COTTAGE CLUSTER

L1

RAISED CENTER COURTYARD

MIXED UNIT CONDOMINIUM

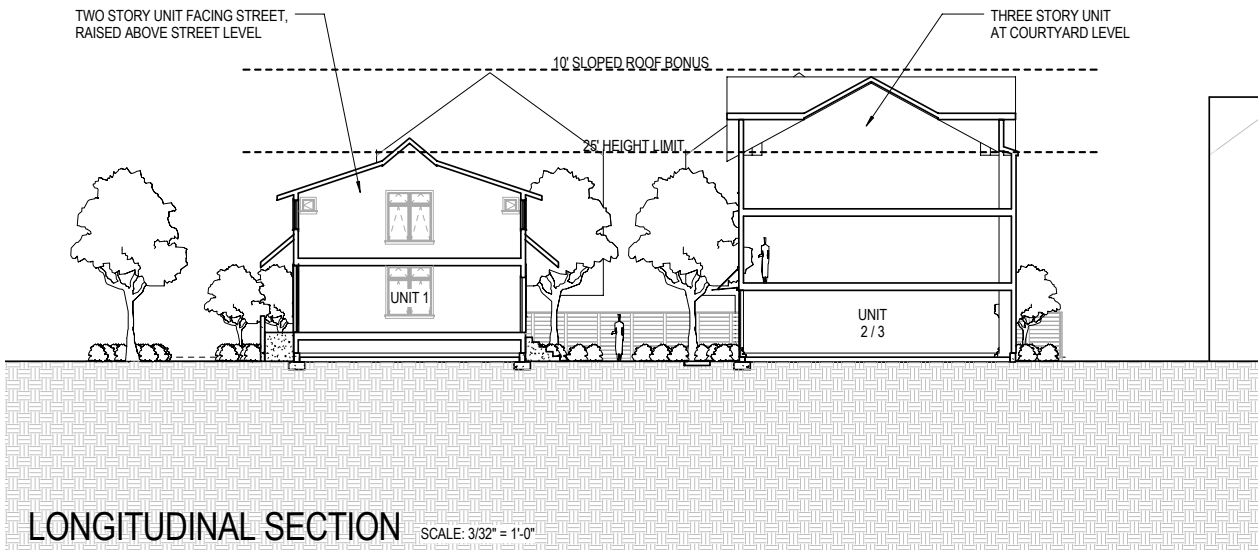
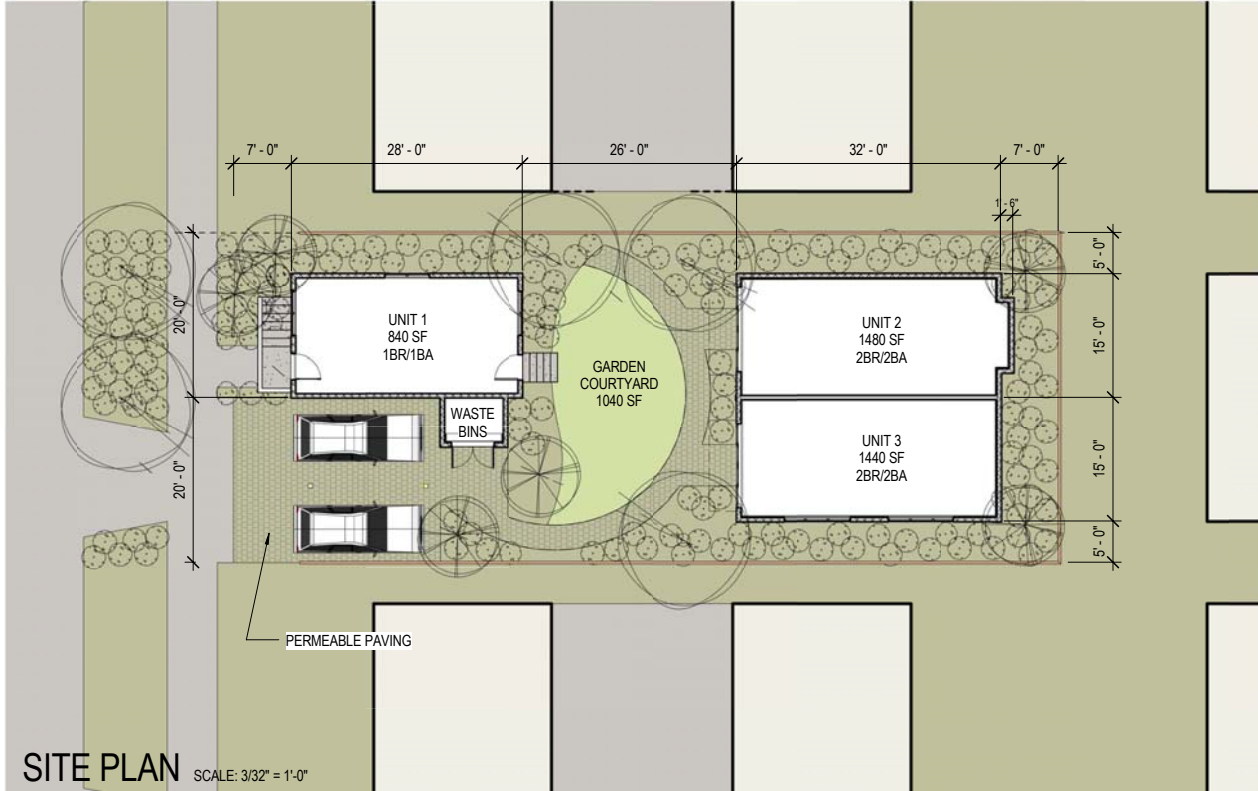
ENABLING FACTORS:
1. The 20% parking reduction is used to provide one fewer parking space, which frees up open space in the center of the site.

GATING MECHANISMS:
1. This scheme works well up to an FAR of about 1.0. As FAR gets higher, the central open space will gradually disappear.
2. This scheme falls apart with more than two parking spaces in the front of the lot.

EVALUATION:
1. Bonus incentives should be provided when projects raise main floor level above street grade.

2. Green factor penalizes projects that provide usable green spaces (lawns). In this case, the scheme's lot coverage is so low that green factor is easily satisfied.
3. Despite its low FAR, none of the project floor area is used for parking. The project has usable interior space comparable to a 1.1 FAR 4-pack.
4. Should the extra parking space come with conditions, for example maximum unit size?

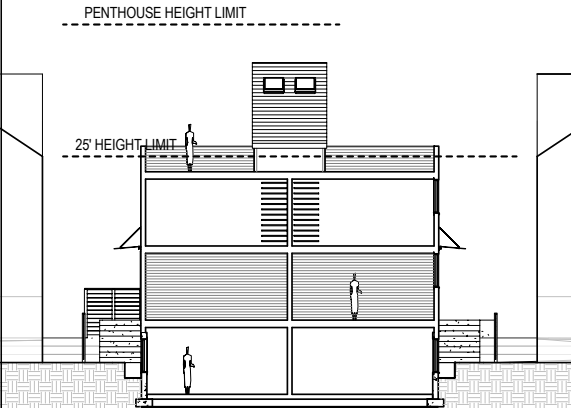
- ENABLING FACTORS:**
- CODE CHANGE: No Density Limits in small L zones.
 - No parking required in station areas.
 - Condominium ownership eliminates problems with unit lot subdivision and flats.

- GATING MECHANISMS:**
- Setting main floor level above the street with a 25' height limit restricts the project to 2 stories above grade.
 - FAR limits prevent the project from expanding into the open space.

- EVALUATION:**
- Lifting the main floor level above street level creates a better relationship between the public & private realm, but causes the project to lose one story of height above grade. If this project were built in a high FAR zone (L3), it would need a third story and a height limit of about 34'. Otherwise, the project would expand into the open space.

- Green factor penalizes projects that provide usable green space (lawn). In this case, the scheme's lot coverage is so low that green factor is easily satisfied.

- Where parking requirements are still in effect, removing density limits would be a fairly modest change, as parking minimums are a density limit as well. In station areas and urban centers where parking is not required, removing density limits could potentially lead to dramatic changes in unit size and affordability.

- Consider incentives for projects that provide basements, including: FAR waiver for basement areas, height bonus for constructing a basement.

TOWNHOUSE INFILL

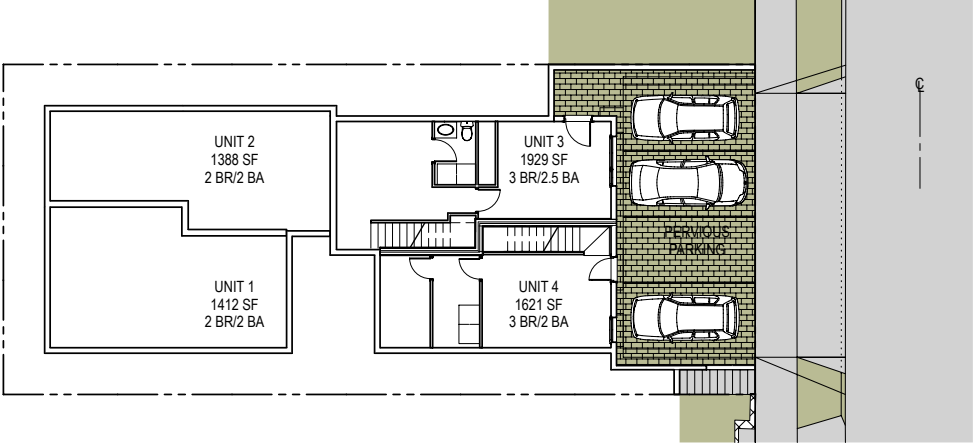
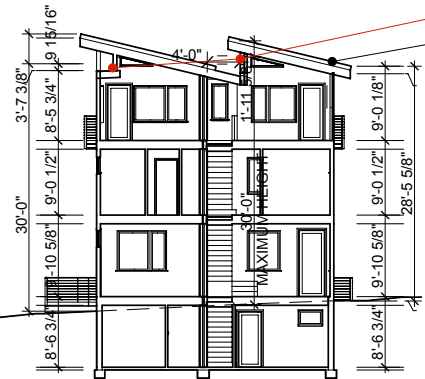
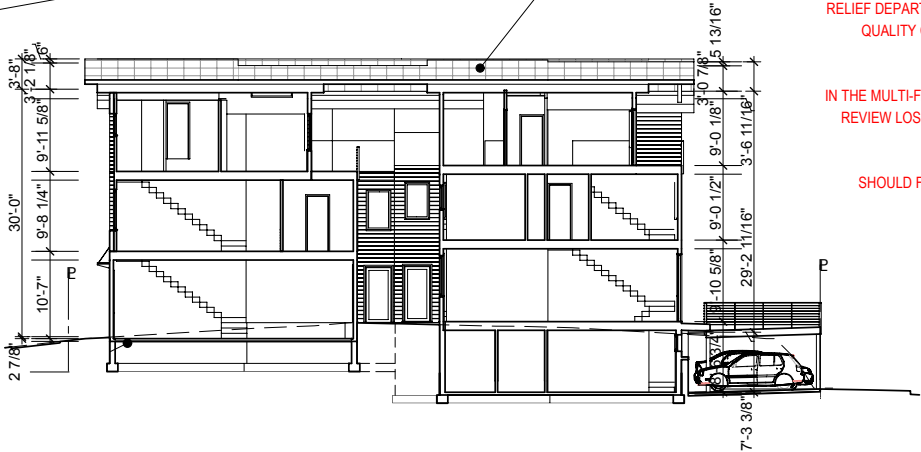
- Shared Amenity space replaces private open space in this scheme, creating a common courtyard at the project's center.
- Reduced setbacks of 7 feet, averaged for the entire site (front + sides + rear / total building face length = average setback instead of averaging each side independently) allows for greater flexibility. This averaging method creates a 5-foot front setback, a 17-foot "rear" setback in the the second "front setback" along the minor street, of the through lot. A courtyard is provided on the south side of the property. Parking is provided at grade at the elevation of the lower street below a green roof.
- Departures are required for an interpretation of the side setback provision, for curb cut width, for clerestories at the roof and for FAR (or an incentive).

- Because basement area is considered part of FAR, the project achieves an FAR of 1.62.
- Because parking is provided through a wide curb cut of the minor street (similar to an alley condition) a high FAR is achievable on this small lot.

- The primary cost factors in this scheme are the roof top photovoltaic solar panels, not addressed sufficiently in the code update, the third floor decks and green roof over parking.

- On a small through lot, 40 feet x 91 feet, flexibility in the code is especially relevant. The flexibility created by going to FAR, reduced setbacks and amenity shared open space, while encouraging sustainable construction choices enables this very site specific scheme.
- The areas for trash can be handled at the front of each car parking stall.
- The proposed roof provides clerestories along the north building façade for the length of the building to bring northern to bring northern light into the units and provide a roof slope for the solar photovoltaic panels.
- All roof types should qualify for the additional 5 feet of height in Lowrise 3 including clerestories and sheds.

CLERESTORY PROVIDED ALONG NORTH PROPERTY LINE AND BETWEEN ROOF SLOPES.

THIS IS A REAL PROJECT RECENTLY APPROVED THROUGH ADMINISTRATIVE DESIGN REVIEW. LOT COVERAGE AND SETBACK RELIEF DEPARTURES WERE GRANTED. GREEN FEATURES AND HIGH QUALITY CONSTRUCTION WERE EXCHANGED FOR EXTRA DEVELOPEMENT POTENTIAL.

IN THE MULTI-FAMILY UPDATE, FAR IS NON-DEPARTABLE, SO DESIGN REVIEW LOSES SOME OF ITS CAPACITY FOR GIVE AND TAKE ON DIFFICULT SITES.

SHOULD FAR BE NEGOTIABLE THROUGH DESIGN REVIEW?
